## REMARKS

Accompanying this Amendment is a letter submitting a substitute drawing to replace original sheet 5 of the drawings. It is respectfully requested that the Examiner indicate whether or not she has reviewed U.S. Patent No. 5,755,160 of Blufordcraving cited in the parent application under the provisions of MPEP 2001.06(f) , and also that this patent be made of record if appropriate.

FIG. 9

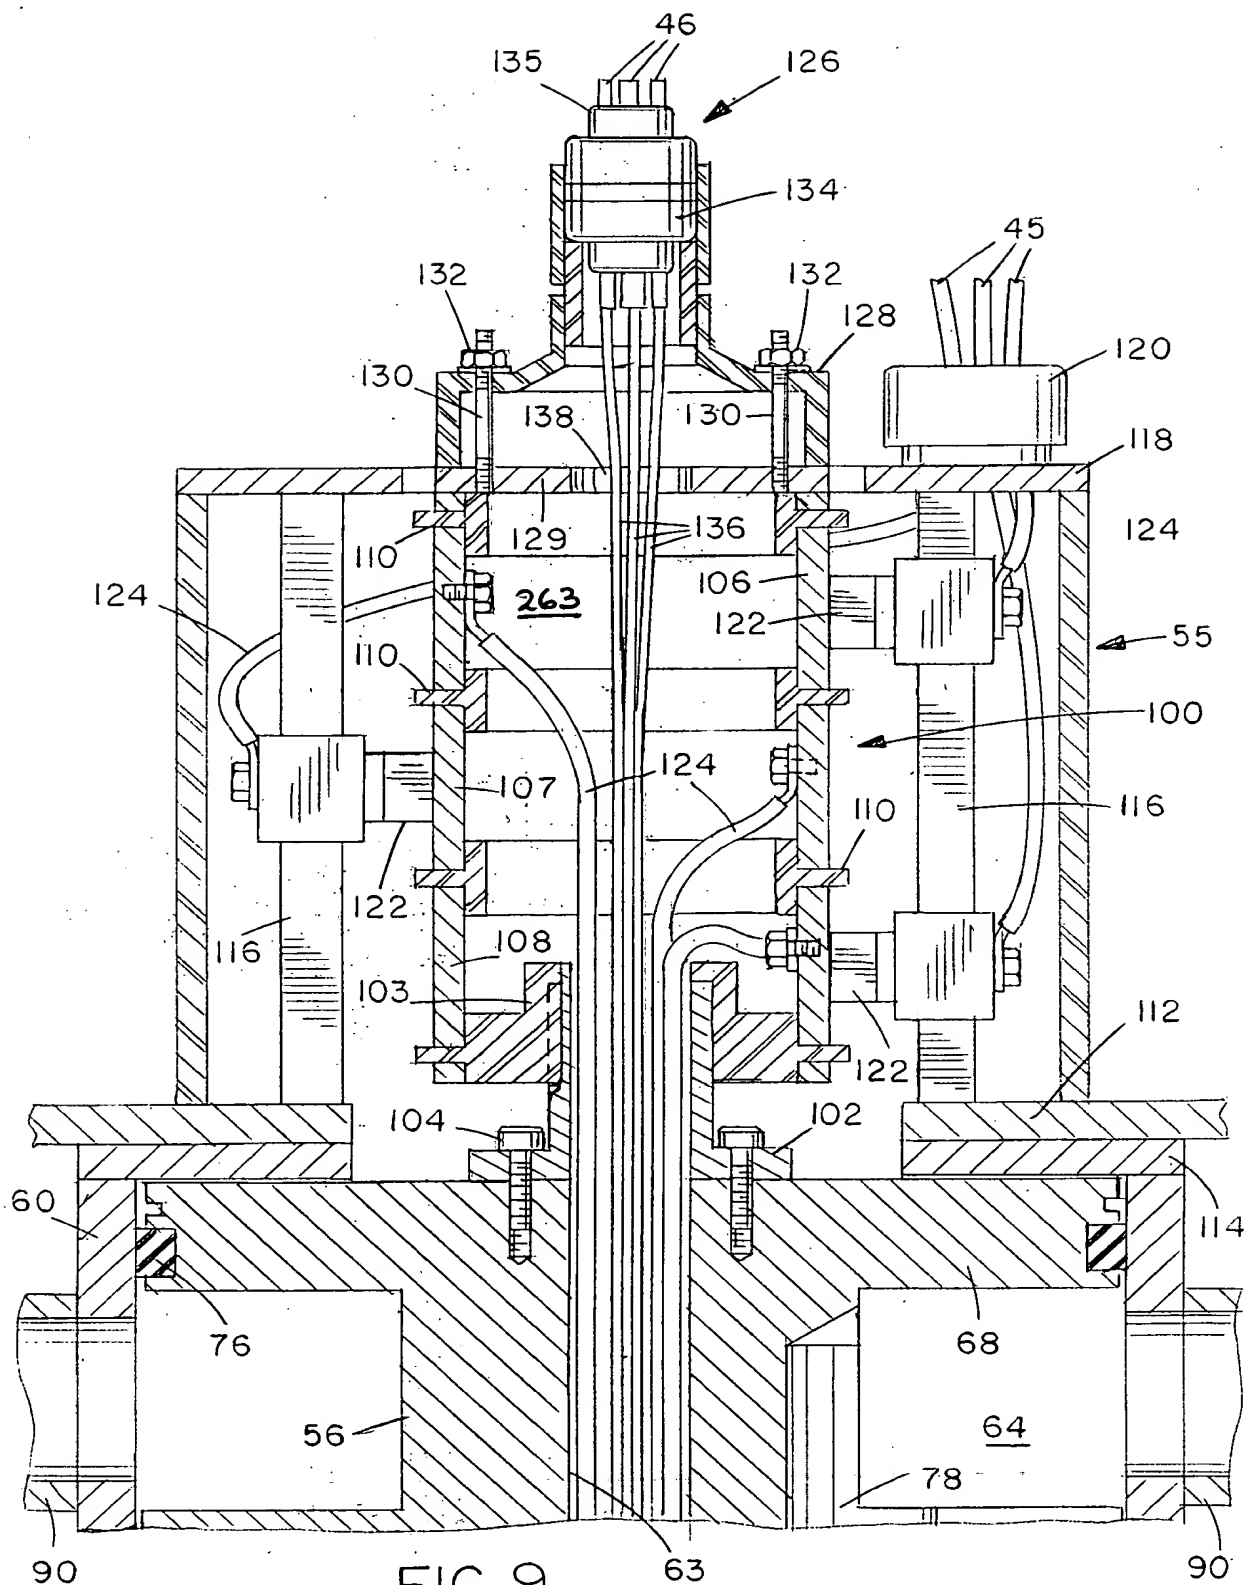
The Examiner objects that the electrical swivel assembly, fixed contact core, aligned central through bores, and outer contact portion of claim 12 are not shown in the drawings, and also that these terms lack antecedent basis and are not clear in the specification. It is submitted that these features were all shown in the drawings as filed and the specification has been amended where appropriate for consistency with the terminology used in claim 12. The electrical swivel assembly 55 is now described specifically in amended paragraph 0035, and the reference to "The upper or electrical portion 55 of the swivel assembly" in the first line of paragraph 0041 has been corrected to read "The upper or electrical swivel assembly 55" for consistency with the claim language. The electrical swivel assembly 55 is clearly illustrated in Figures 3 and 9. The term "electrical swivel" in paragraph 0042 has been corrected to read "Electrical swivel assembly 55" for consistency with the remainder of the specification and claims.

The Examiner has also objected that the rotary connector, a fixed part of the connector, fixed electrical service lines, and conductors of claim 13 are not illustrated in the drawings and are unclear. Again, it is submitted that these objections result only from slight differences in terminology used in the specification and claims. In the foregoing amendment, claim 13 has been amended for consistency with the wording used in the specification, as follows:

The specification has also been revised in paragraph 0041 to change "inner fixed power conducting core 100" to "inner fixed contact core 100" for consistency with claim 12, and the contact core 100 is clearly illustrated in Figure 9. Paragraph 0041 has also been amended to specifically describe the aligned central through bores 63 and 263 in the first member or spool 56 and the contact core 100, as illustrated in Figure 9. The central through bore in the contact core 100 has been provided with a reference number 263 in the enclosed amended Figure 9. Paragraph 0042 has also been amended to change "outer rotating portion" to "outer contact portion" for consistency with claim 12. Again, Figure 9 clearly illustrates that the outer contact portion is secured to the outer swivel casing or second member 60, the outer contact portion comprising upwardly projecting posts 116 carrying contact brushes 122 in the exemplary embodiment.

“Rotary connector” has been changed to “rotating electrical connector” – The rotating electrical connector 126 is described in paragraph 0043 and is clearly illustrated in Figure 9.

“Fixed part” (of the rotating electrical connector”) has been changed to “fixed portion”, for consistency with the terminology used in paragraph 0043, specifically “lower fixed portion 134”. The fixed portion 134 is also clearly illustrated in Figure 9.

“Rotary part” (of the rotating electrical connector”) has been changed to “rotating portion”, for consistency with the terminology used in paragraph 0043, specifically “upper rotating portion 135”. The rotating portion 135 is also clearly illustrated in Figure 9.

The phrase “and having conductors” has been deleted in amended claim 13. The term “fixed electrical services lines” in claim 13 listed by the Examiner has proper antecedent basis in the specification and is also illustrated in the drawings. “Fixed electrical service lines 136” are described in paragraph 0043 of the specification and illustrated in Figure 9.

It is submitted that the foregoing amendments to claim 13 and the above comments deal with all of the Examiner’s objections to this claim, and that all elements of this claim have proper antecedent basis in the specification and are illustrated in Figure 9.
